Product Change Notice (PCN)

PCN Number: PCN-0456166R

Product(s) Affected: *PJ-036CH*

PREVIOUS CUI DEVICES DETAIL / IMAGE	NEW CUI DEVICES DETAIL / IMAGE

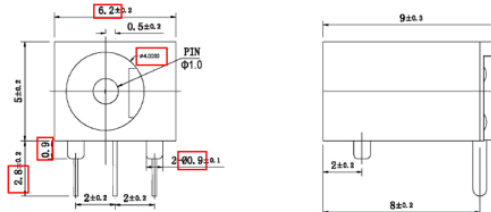
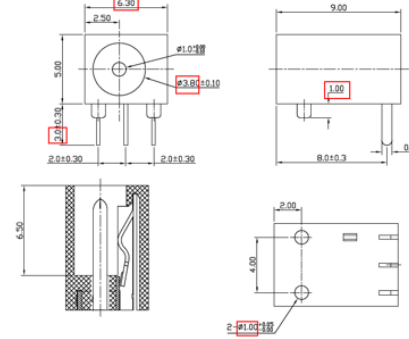
Description of Change: *New Factory Location. Product re-engineered for improved manufacturability and production yield. See image below for reference and check CUI Devices website for updated drawing. Cosmetic differences may be visible and not affect the form fit and function of the product.*

PREVIOUS CUI DEVICE'S DETAIL / IMAGE			NEW CUI DEVICE'S DETAIL / IMAGE		
DESCRIPTION	MATERIAL	PLATING/COLOR	DESCRIPTION	MATERIAL	PLATING/COLOR
center pin	brass	silver	center pin	brass	silver
terminal 1	brass t=0.25	silver	terminal 1	brass t=0.25	silver
terminal 2	brass t=0.25	silver	terminal 2	SUS301 t=0.25	silver
terminal 3	brass t=0.25	silver	terminal 3	brass t=0.25	silver
housing	PBT (UL94V-0)	black	housing	PPA (UL94V-0)	black

<p>MATING PLUG Jack Insertion Depth: 6.4 mm</p>	 <p>MATING PLUG Jack Insertion Depth: 6.5 mm</p>
---	--
